Road & Bridge Design Publications

Monthly Update – August 2016

Revisions for the month of **August** are listed and displayed below. New special details will be included in projects submitted for the **November** letting as is stated on the special detail index sheets. E-mail Road related questions on these changes to MDOT-Road-Design-Standards@michigan.gov. E-mail Bridge related questions to MDOT-Bridge-Design-Standards@michigan.gov.

F.H.W.A. APPROVAL	8-1-2016 PLAN DATE	R-61-H	SHEET 6 OF 19
-------------------	-----------------------	--------	------------------

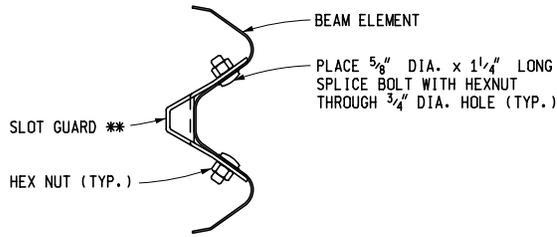
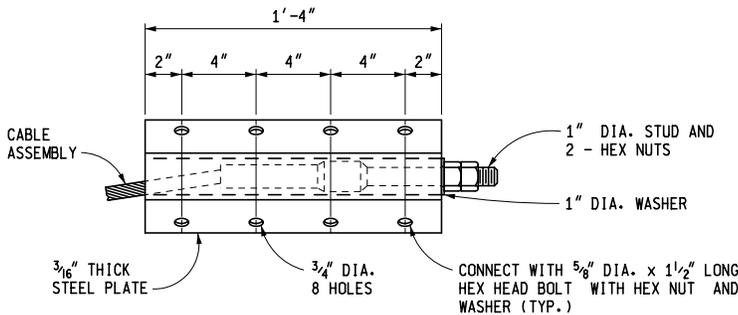
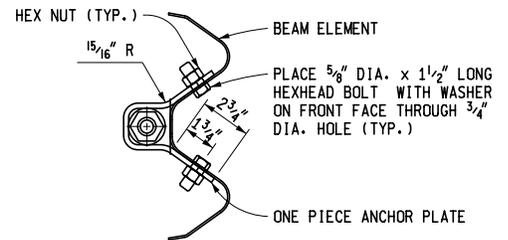
R-61-H: Guardrail Approach Terminal Types 1B & 1T: Added two notes on sheet six in regards to the proper location of slot guards and guardrail panels on the SRT ending.

* INSTALL THE SLOTTED RAIL BEAM ELEMENTS IN THE ORDER AND ORIENTATION DETAILED ABOVE SO THAT THE SLOT GUARD ATTACHMENT HOLES ARE ON THE DOWNSTREAM END (AWAY FROM POST 1) OF THE ELONGATED SLOTS.

** PLACE THE SLOT GUARD SO THAT THE DEFLECTOR ANGLE GAP OPENS IN THE DIRECTION FACING THE ADJACENT SLOTS AND POST 1.
